Re:	Initial Submission Review	Blue Eagle Logistics Park - Master Plan
	Application Number:	DA-2375-00
	Case Numbers:	2024-7001-00

PLANNING DEPARTMENT COMMENTS

PA-4
5 OF 7

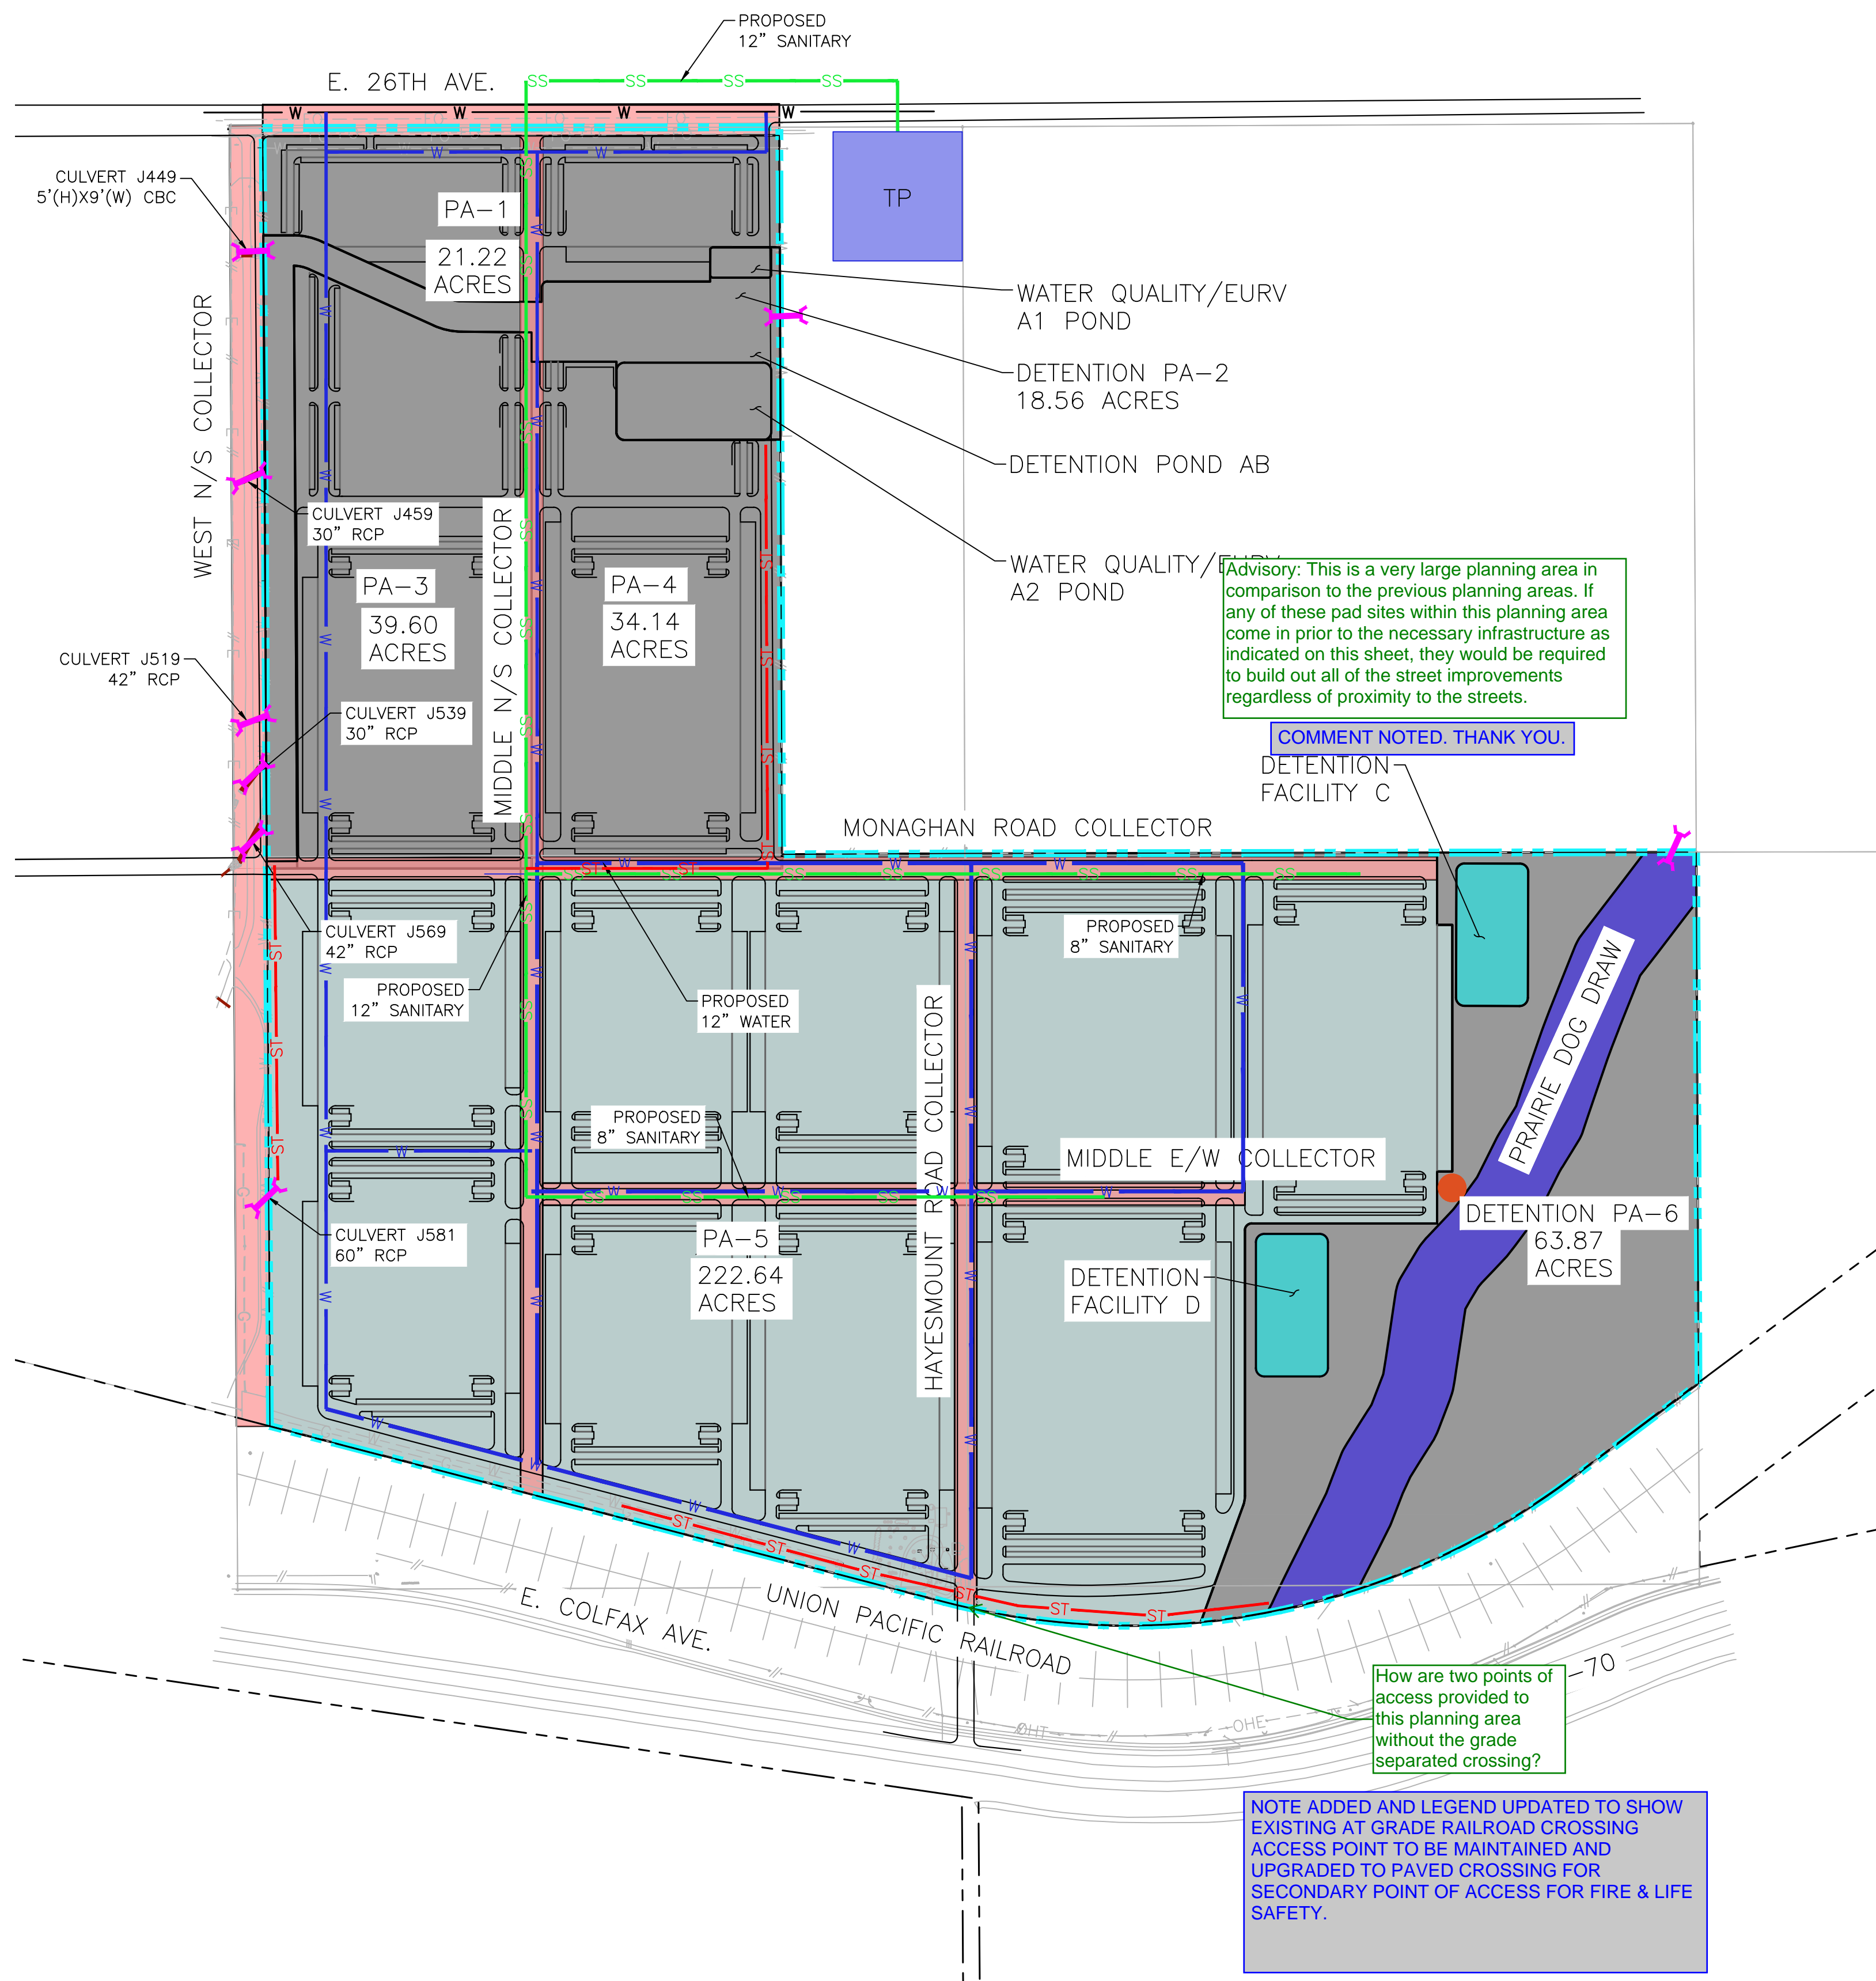
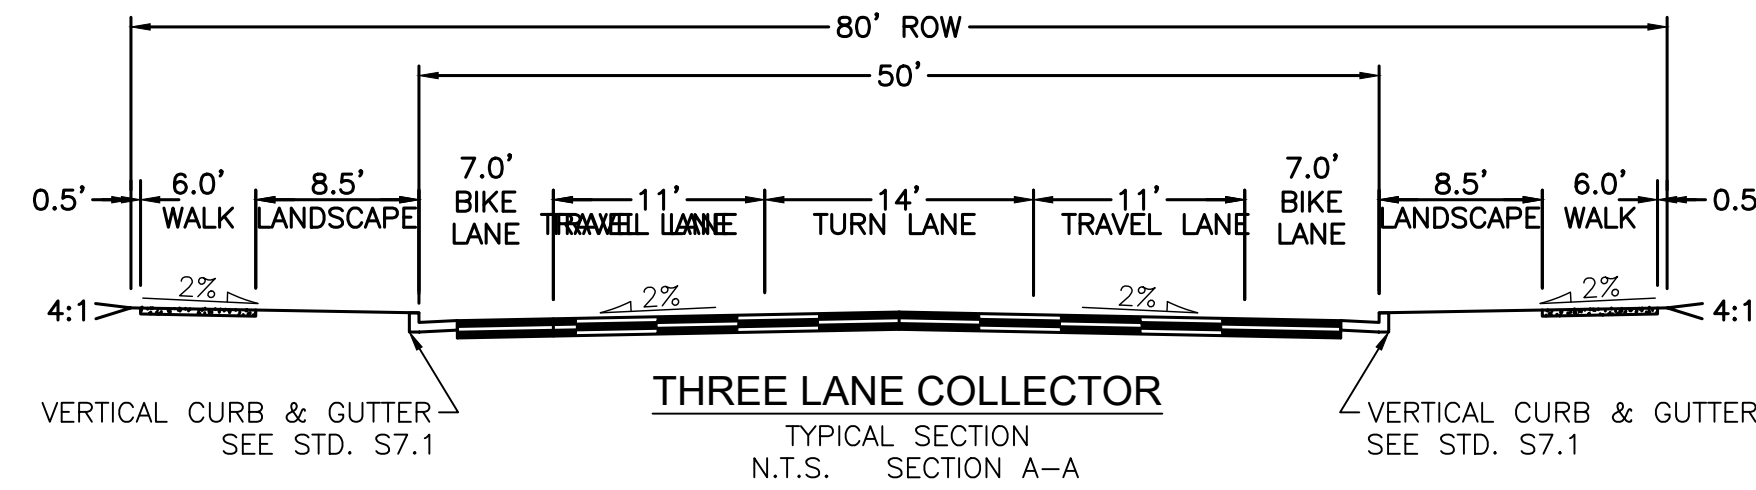
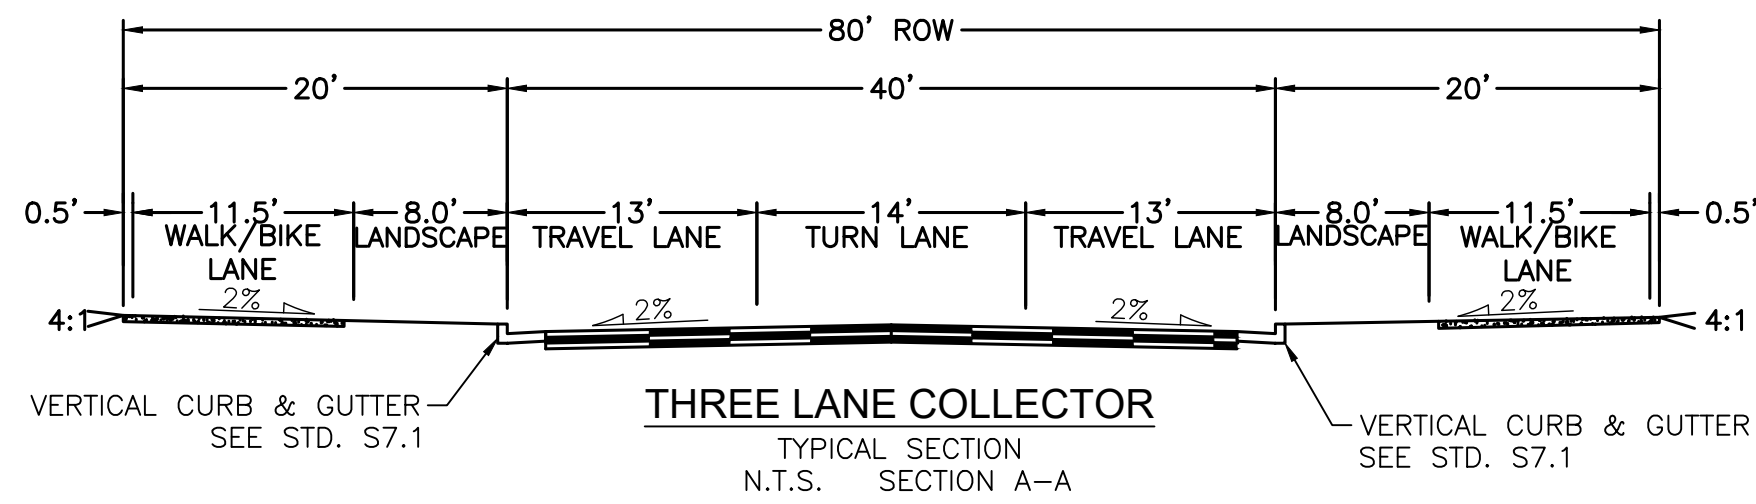
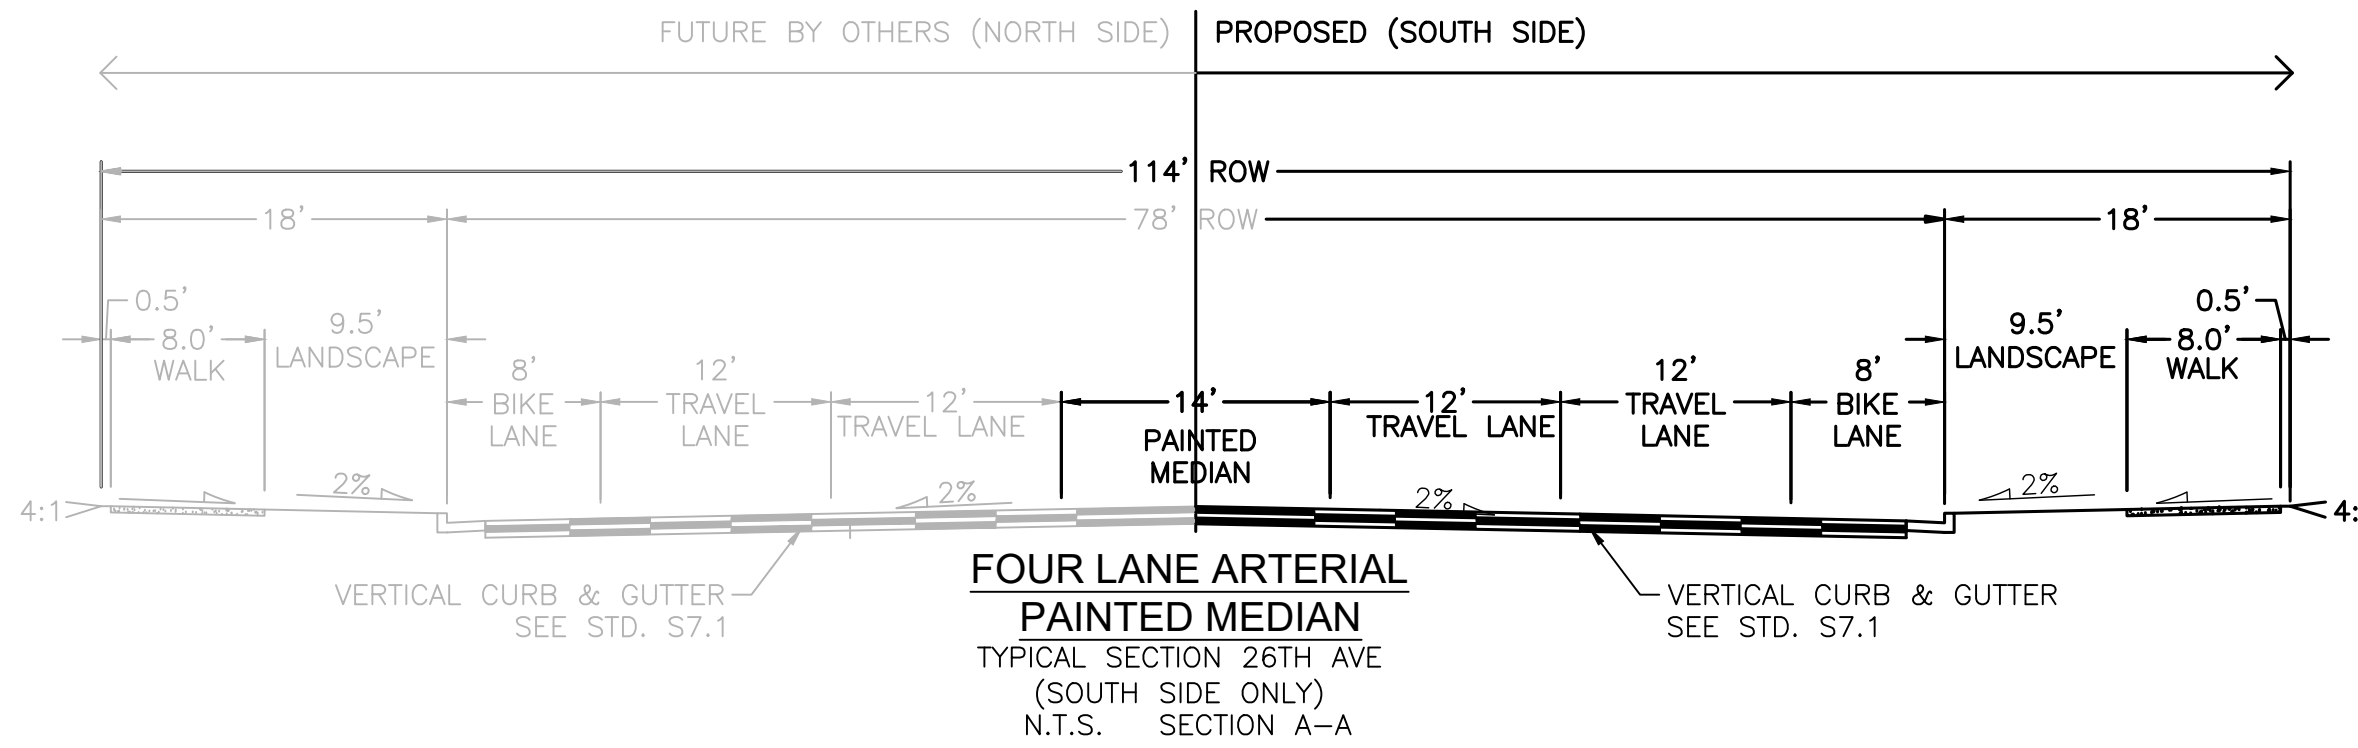
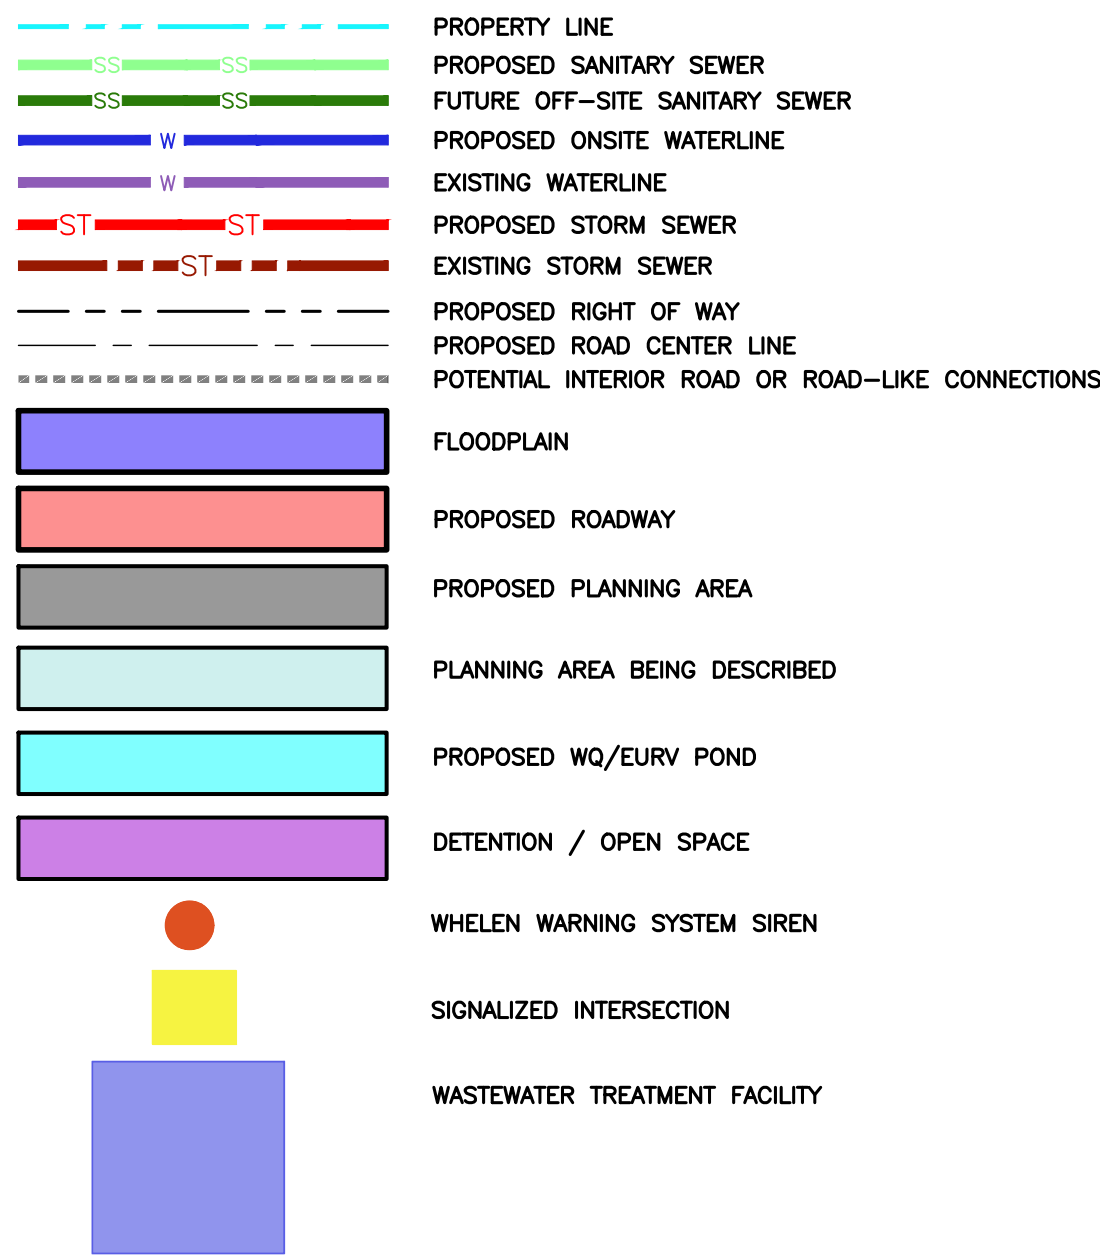
How are two points of access provided to this planning area without the grade separated crossing?

NOTE ADDED AND LEGEND UPDATED TO SHOW EXISTING AT GRADE RAILROAD CROSSING ACCESS POINT TO BE MAINTAINED AND UPGRADED TO PAVED CROSSING FOR SECONDARY POINT OF ACCESS FOR FIRE & LIFE SAFETY.
